TCEP No.: 787-002-12

### **ADDENDUM NO. 3**

**Fillmore Central**  
1410 'L' Street  
Geneva, Nebraska 68361  
TCEP No.: 787-002-12

**9 STAIR & ADA LIFT SECTION**  
SCALE: 3/4" = 1'-0"

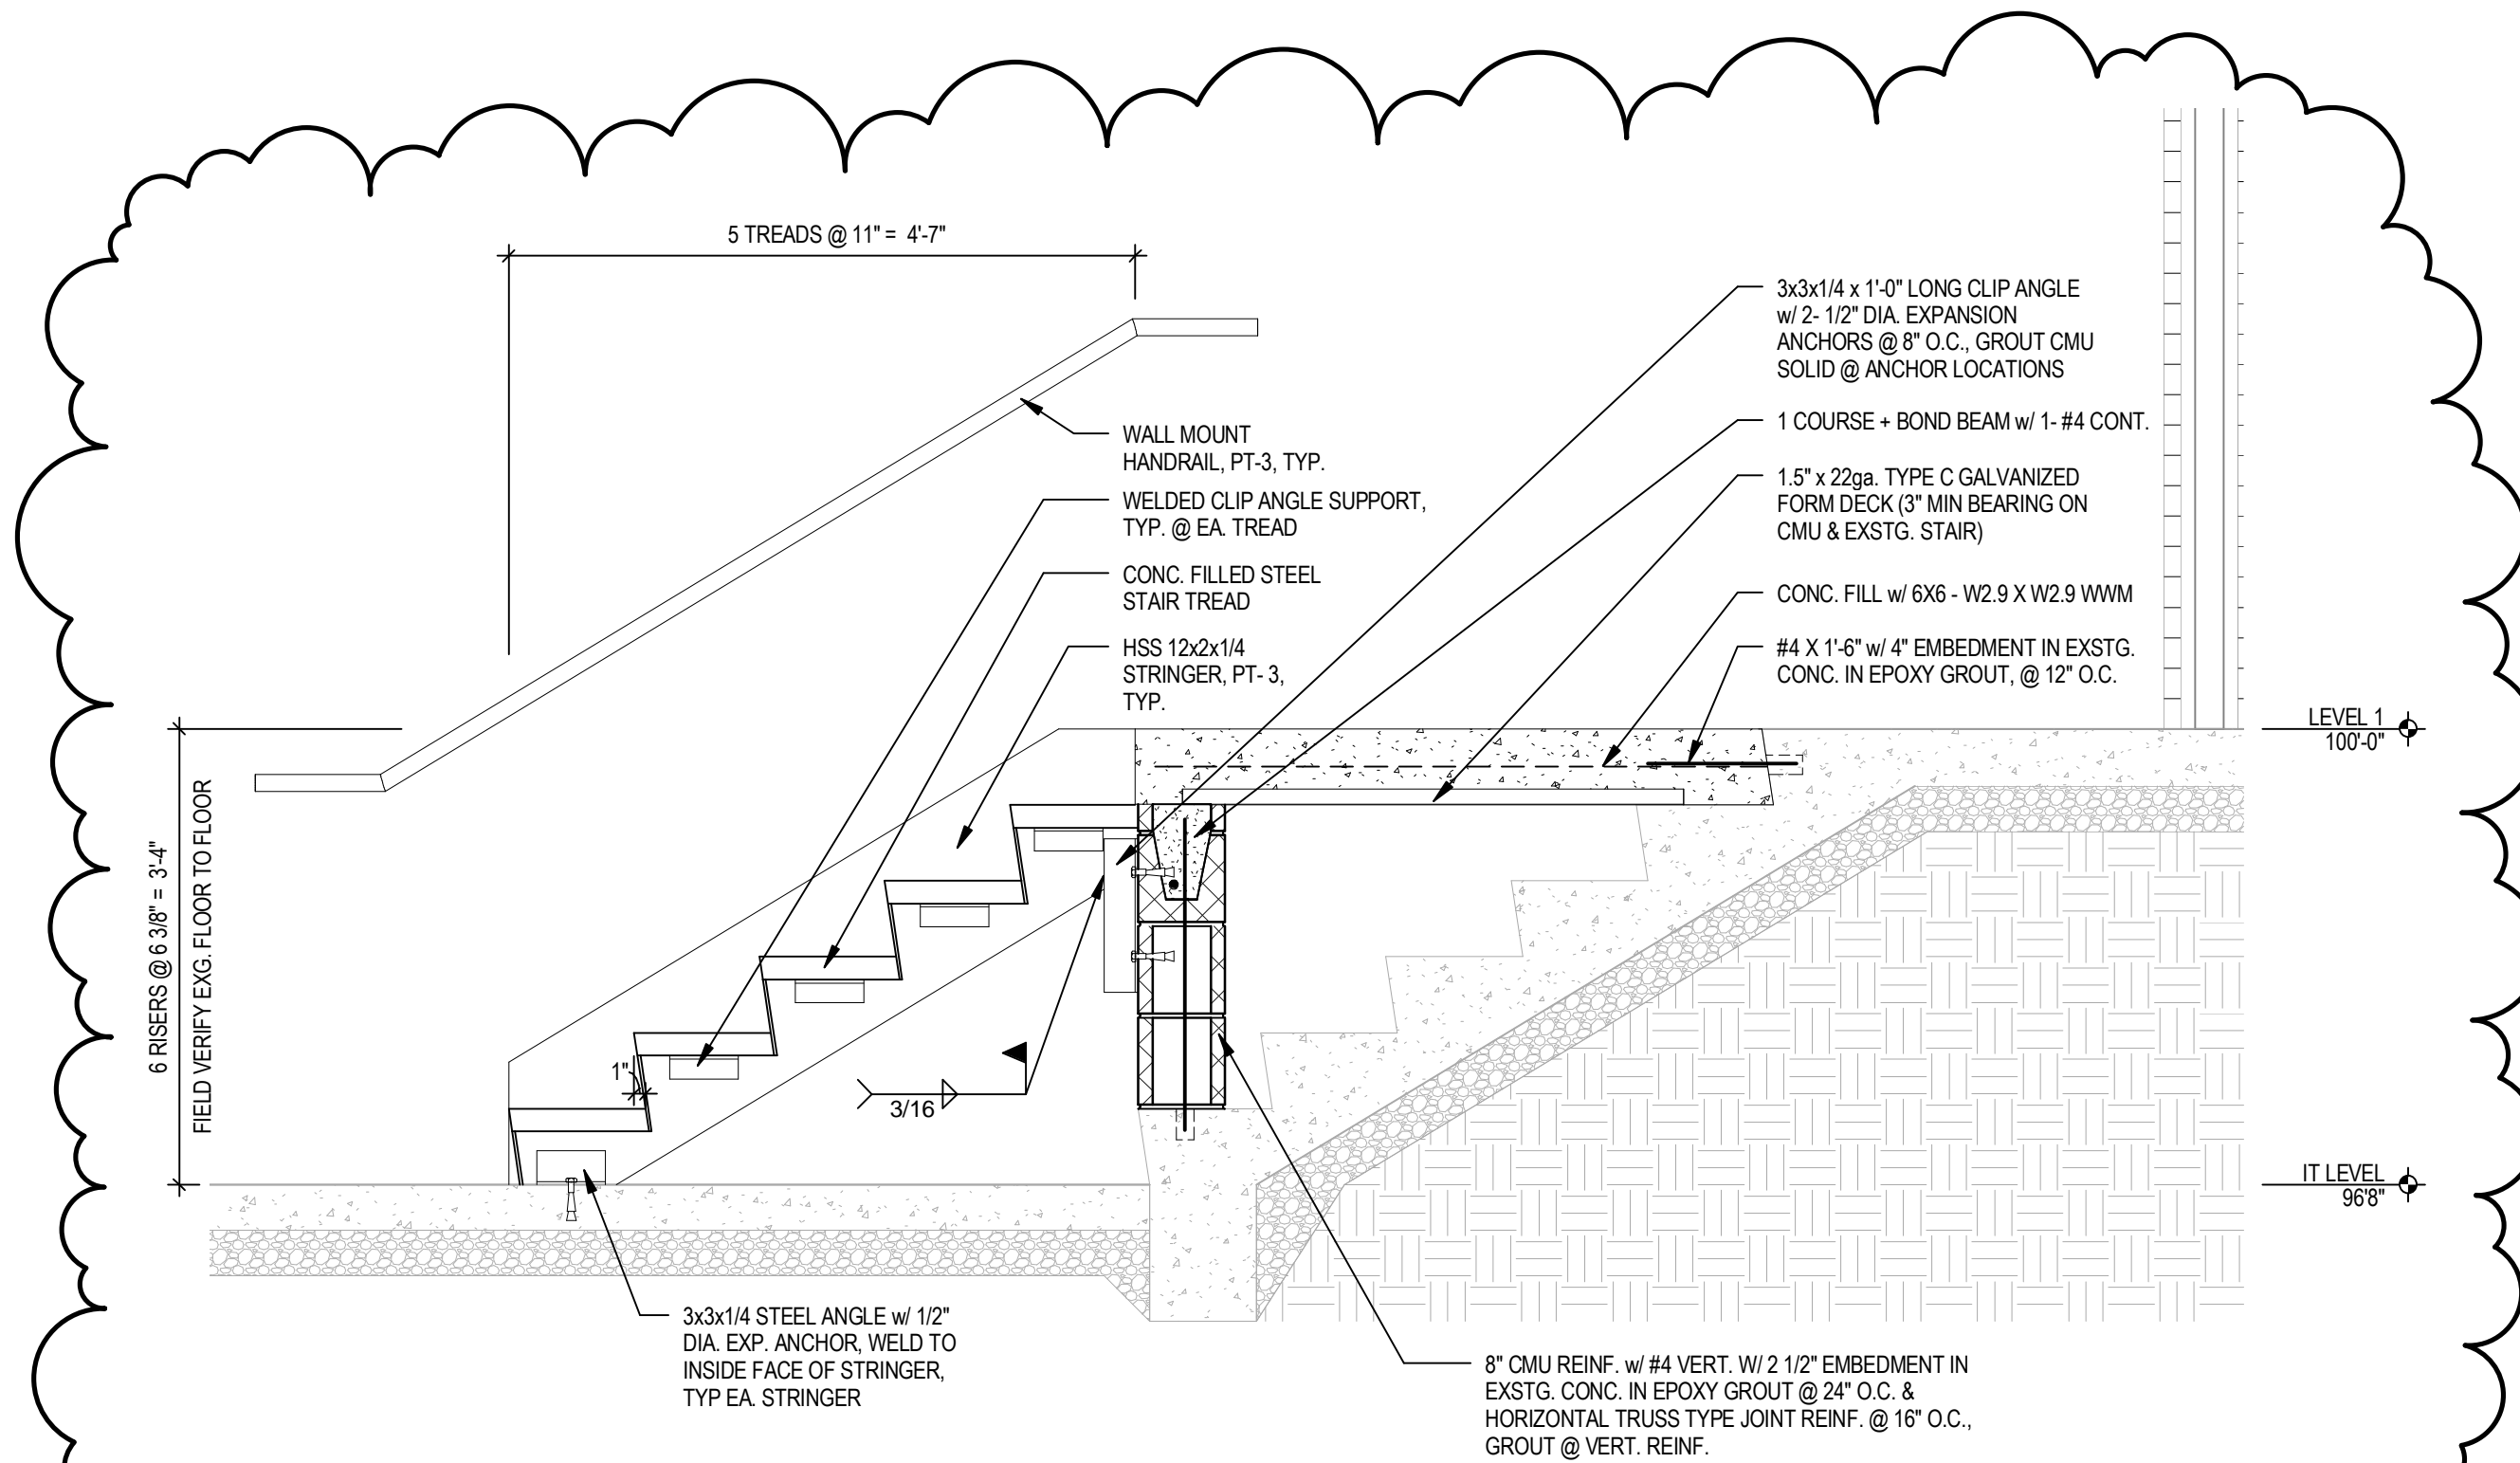
Add detail 9, supplemental drawing SDA-001 for a clarification of the construction of the stair extension construction south of the new ADA lift.
